Memo

Subject: DA2024/0492 – 49 Blackbutts Road, Frenches Forest

Record Number: 2025/138487

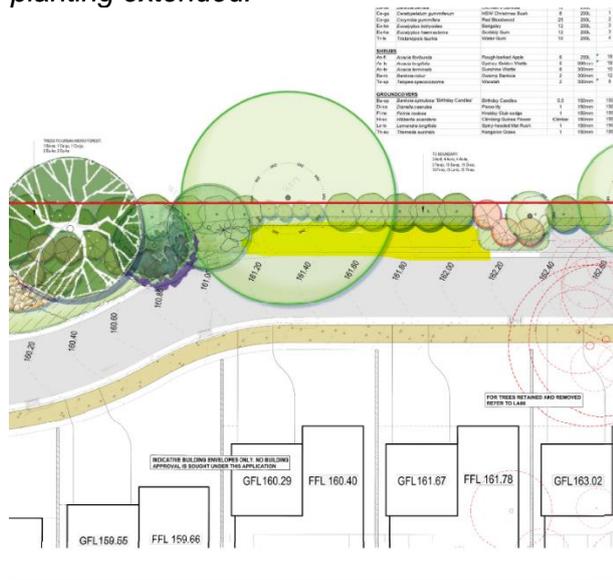
Concerns raised by the applicant with potential impacts that this condition may have on the sewer are noted. However, it is recommended the condition is kept as it is necessary to minimise impact to neighbours.

To provide some flexibility in the design but keep the landscaped buffer, an amendment is recommended to the condition to provide as a minimum rather than absolute. This allows the buffer to be larger if required for design of stormwater and avoidance of sewer.

Further, the condition has been amended to increase from 1.2m to 2m in accordance with the panel's suggestion.

9. Amendments to the approved plans

- i) *the retaining walling along the along the eastern boundaries of lots 5 to 13 inclusive shall be relocated to provide an unobstructed landscape planting zone (a minimum of 2m wide). The stormwater pits and drainage lines shall be relocated accordingly.*
- ii) *Along the entire southern boundary of lot 13, species obtaining a mature height of between 2m to 4m are to be provided.*
- iii) *Along the northern boundary (lots 5-13), species obtaining a mature height of 3m to 4.5m are to be provided.*
- iv) *The three on-street car parking spaces to the south (highlighted in yellow below) are to be deleted and replaced with landscaping with proposed planting extended.*

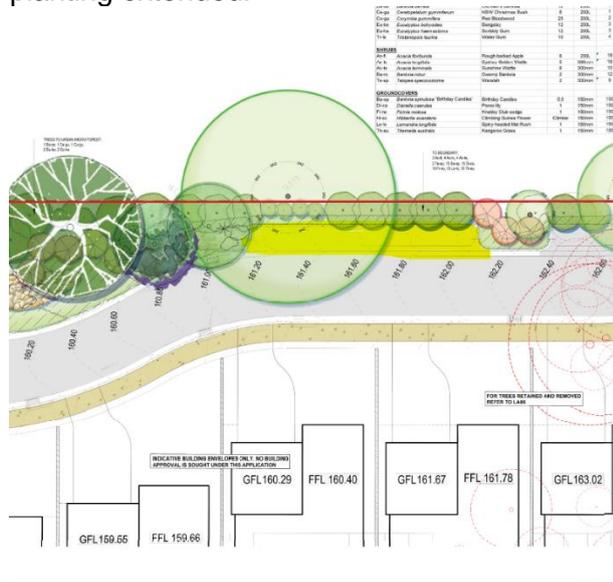
2. Amend Condition 9 as follows:

- i) *the retaining walling along the along the eastern boundaries of lots 5 to 13 inclusive shall be relocated to provide an unobstructed landscape planting zone (a minimum of 2m wide). The stormwater pits and drainage lines shall be relocated accordingly.*
- ii) *The three on-street car parking spaces to the south (highlighted in yellow below) are to be deleted and replaced with landscaping with proposed*

planting extended.
